**RECALL
BULLETIN:**
170914REV

Fleetwood Bounder
manufactured
March 24, 2014
through May 22,
2015 (DC Level
510 thru 609)

Fleetwood
Southwind
manufactured
March 11, 2014
through March 2,
2016 (DC Level
500 thru 625)

SUBJECT:
Inspection /
Correction of
Battery Tray
Installation

Figure 1

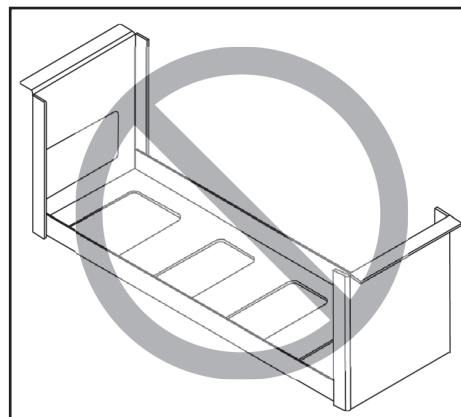
- a) If the battery tray is formed as one solid piece (has no angle steel members) as shown in **Figure 1**, no repairs are necessary. Take photos and then reinstall the entry step cover. Ensure the bulb seal is properly positioned around the perimeter before reinstalling the cover.

If the battery tray is formed as one solid piece as shown above, no repairs are required.

Figure 2

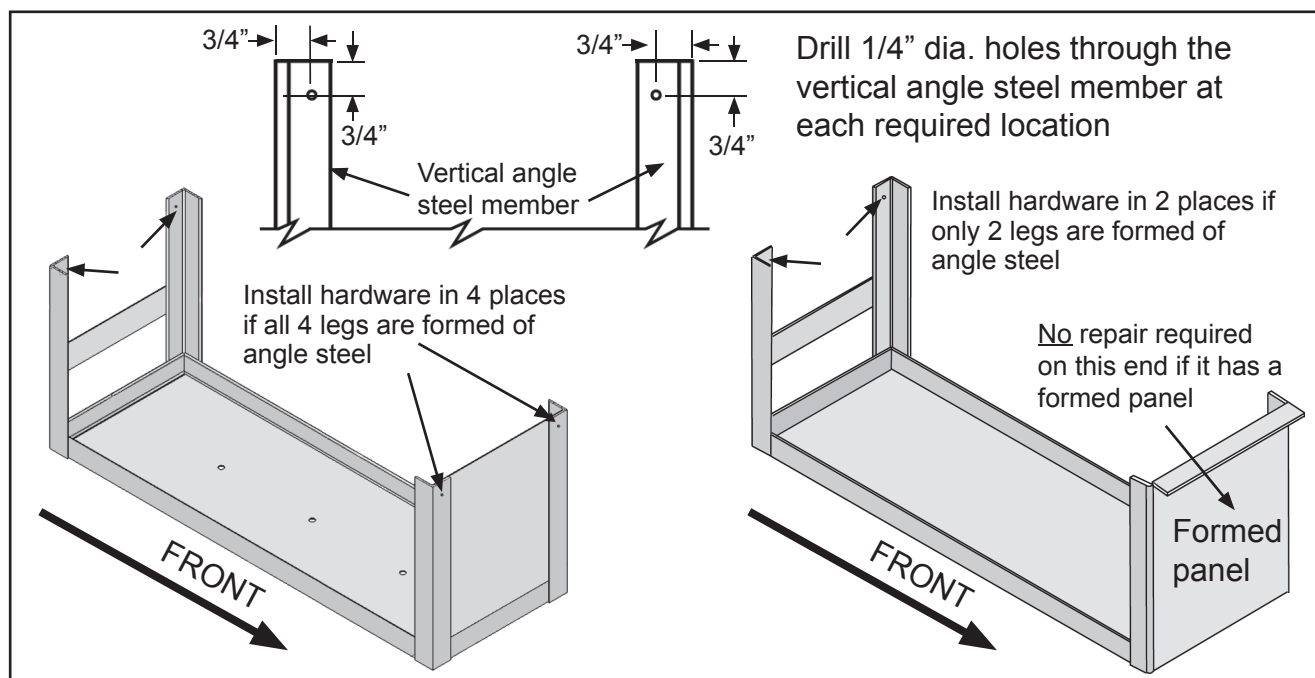
On motorhomes affected by this recall, the welds on the battery tray, attached to the underside of the chassis bridge, may be insufficient. If the welds are insufficient they may break and allow the battery tray to partially or fully detach from the chassis bridge.

- b) If the battery tray has 2 or 4 vertical members composed of angle steel as shown in **Figure 2**, continue to CORRECTION, Step 5, next page.

If the step cage is constructed with either (2) or four (4) angle steel members, repairs are required.

5. Locate the upper corners of the battery tray's vertical angle steel members. Using **Figure 2** on Page 2 as a guide, drill a 1/4" diameter hole through the vertical angle steel and the chassis structural steel, in each required location.
6. Install a grade 5 bolt, two flat washers, and a nylon lock nut at each newly drilled location, using the stacking order shown in **Figure 3**. Tighten nuts to 12 -15 ft./lbs. See Parts list for hardware requirements.
